Keysbrook Mineral Sands Mine

Olympia Resources Limited

**Report and recommendations
of the Environmental Protection Authority**

**Environmental Protection Authority
Perth, Western Australia
Bulletin 1269
October 2007**

Figure 4: Mine area

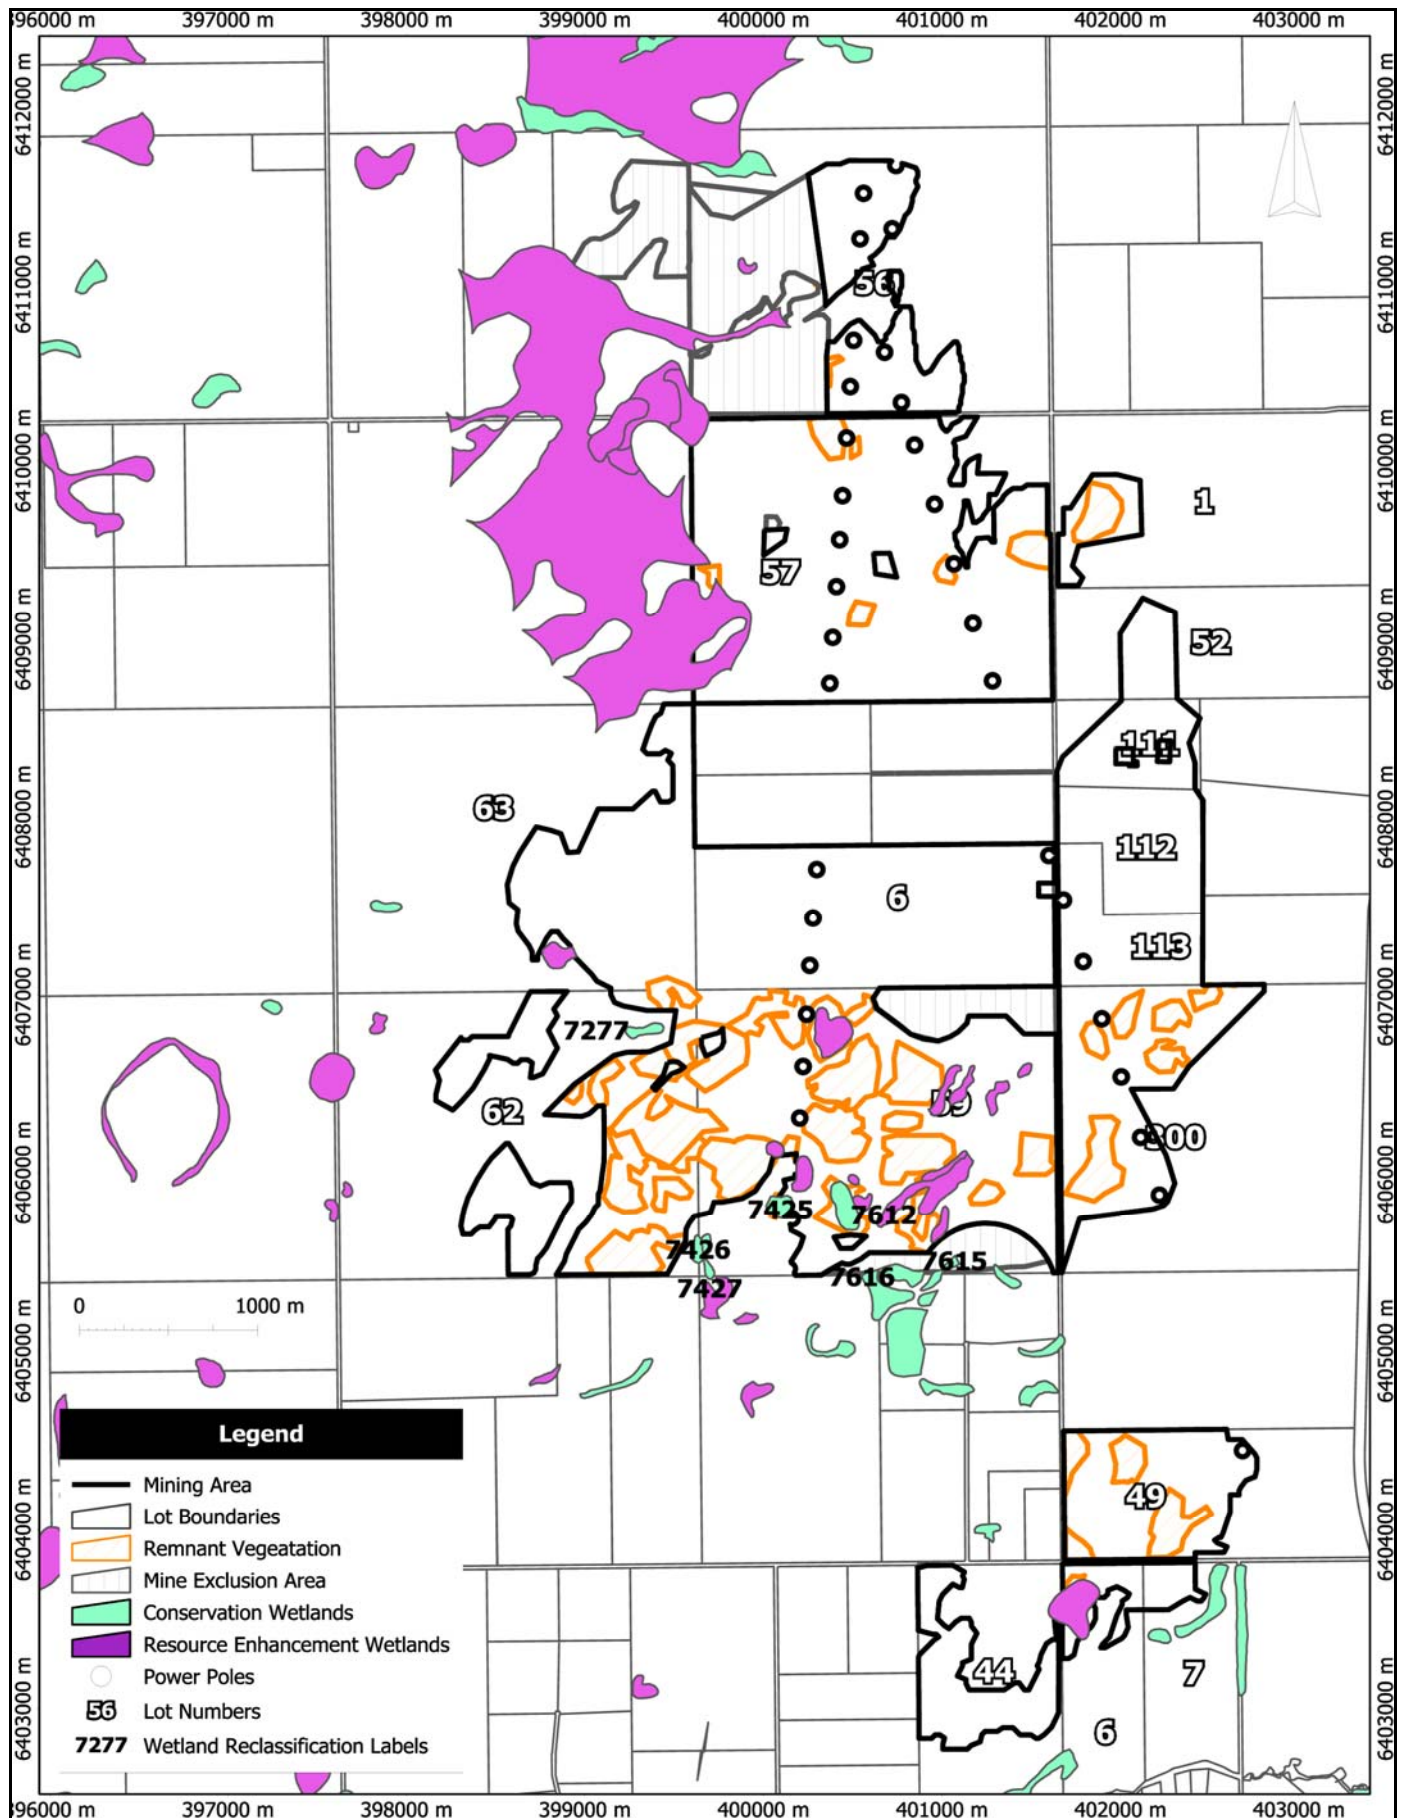
For these reasons, the EPA advised the proponent that the proposal to clear remnant native vegetation on Lots 56 and 3 would not be supported. As a result, the proponent excised these areas from the mine plan.

1. Implement a mine exclusion area (Figure 4) of 87ha of vegetation on Lots 56 and 3 that contain suitable habitat for all three species of black cockatoo and other birds. An additional consolidated area of vegetation on Lots 59 and/or 62 would also be excluded from mining.

For these reasons, the EPA advised the proponent that the proposal to clear remnant native vegetation on Lots 56 and 3 would not be supported. As a result, the proponent excised these areas from the mine plan.

Figure 5: Groundwater production and monitoring bores

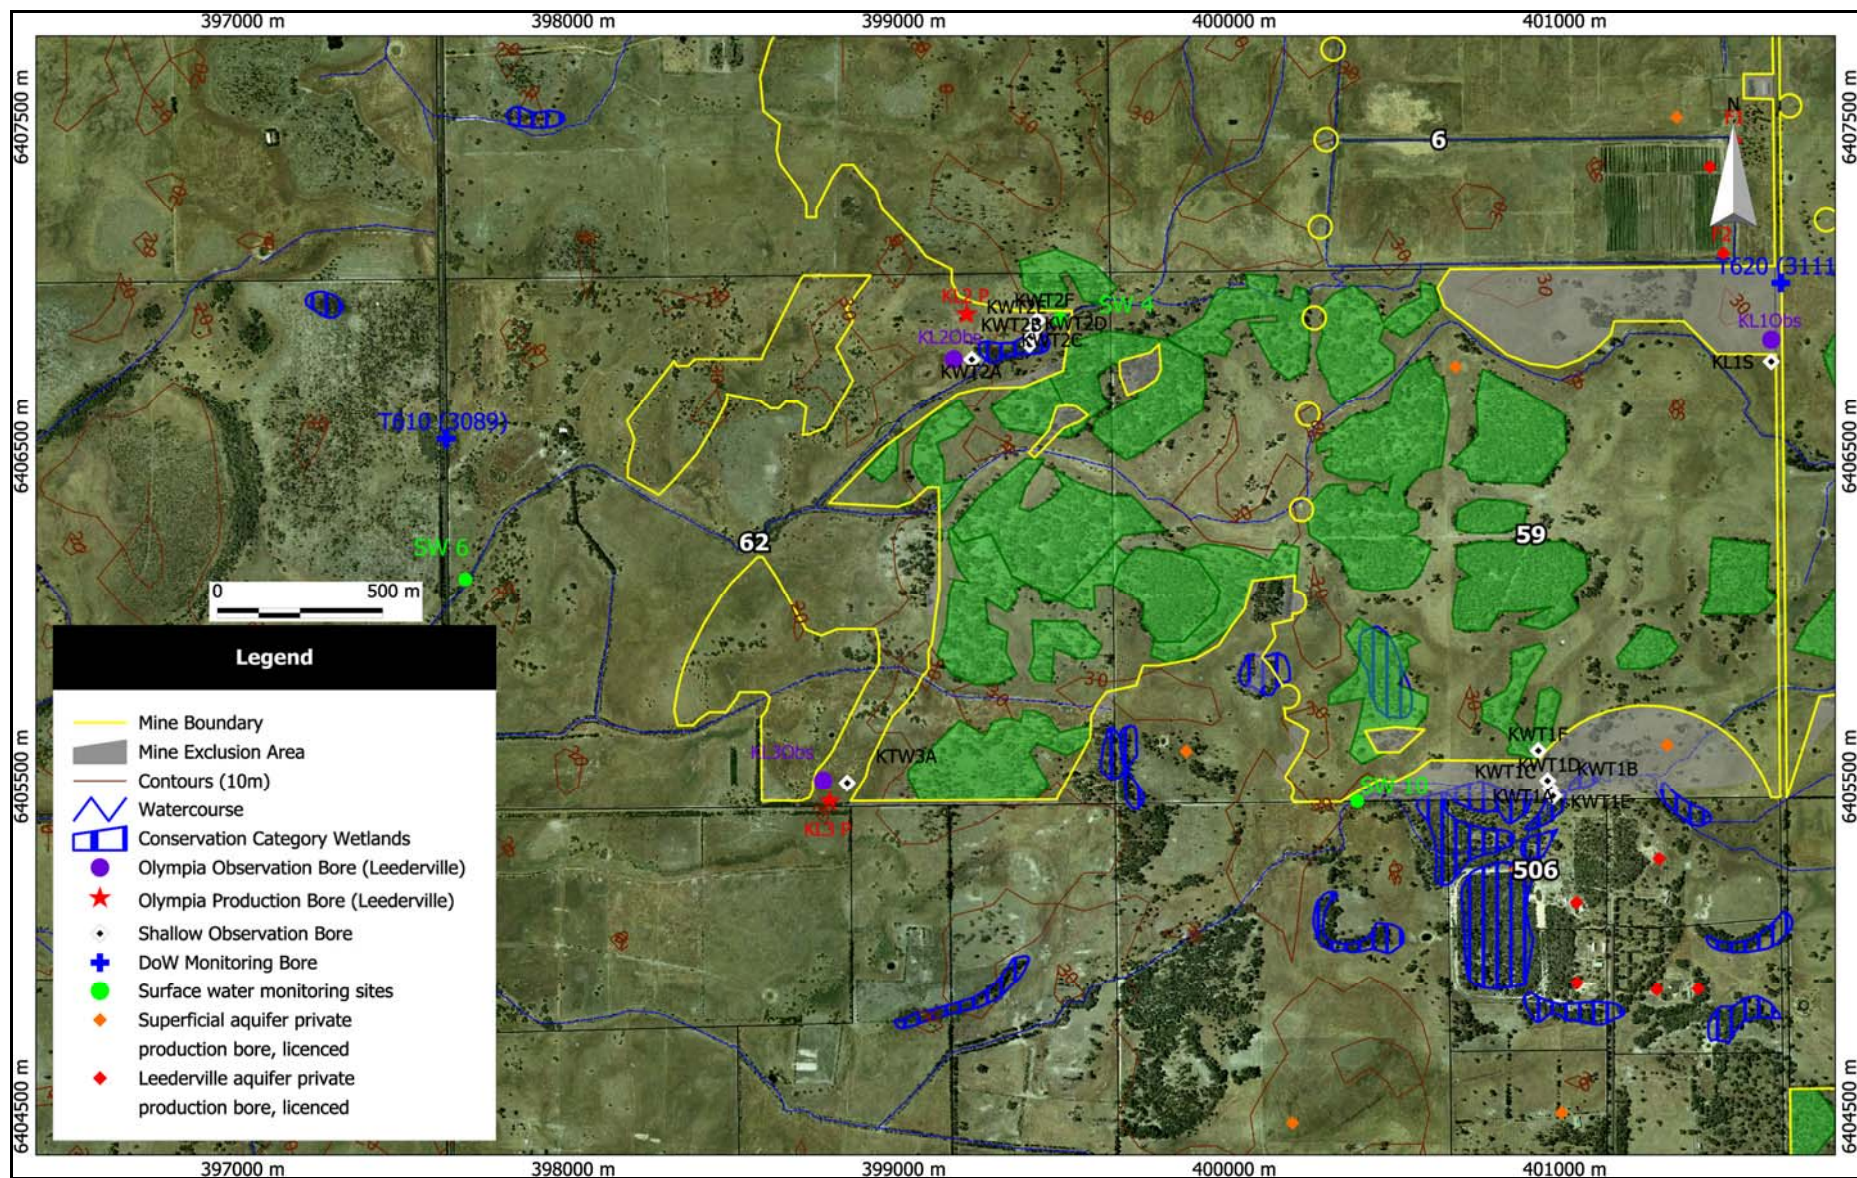
Superficial aquifer bores were drilled along two sections leading into wetlands (Figure 5). Section 1 consisted of monitoring bores (KWT1A-F) on Lot 59 near the mapped CCWs adjacent to the mine area. Here, the Bassendean Sand Formation is unsaturated in summer/autumn. Relative levels in the bores in May were between 29.69m Australian Height Datum (AHD) and 31.27mAHD. The base elevation of mining in this area is 29.8mAHD, so there would be no discernible lowering of the summer watertable at the wetlands. If this area was mined in winter/spring, and the watertable at the edge of the mine area was maintained at 30mAHD, the water level could not be lowered below 30mAHD at the edge of the wetlands. Negligible drawdown is expected at the wetland. Based on the measured water levels and allowing for a 1m rise in winter, the watertable would not reach ground surface in the wetland unless there was additional recharge from surface water (Rockwater, 2007).

Production bores KL2P and KL3P (Figure 5) were constructed to the base of the Leederville Formation, and three observation bores (KL1Obs, KL2Obs and KL3Obs) were constructed in the Leederville aquifer. The effects of abstracting from the Leederville aquifer on the superficial aquifer was measured at bore KWT3A, during the pumping test of bore KL3P. The drawdown recorded at KWT3A was 0.04m after 44 hours, compared with 3.5m in the Leederville aquifer (at KL3Obs). For a pumping rate of 2,740 kilolitres per day (1.6 times that of the test) for 8 years, the drawdown at KWT3A was extrapolated to average 0.06m/yr, not including recharge.
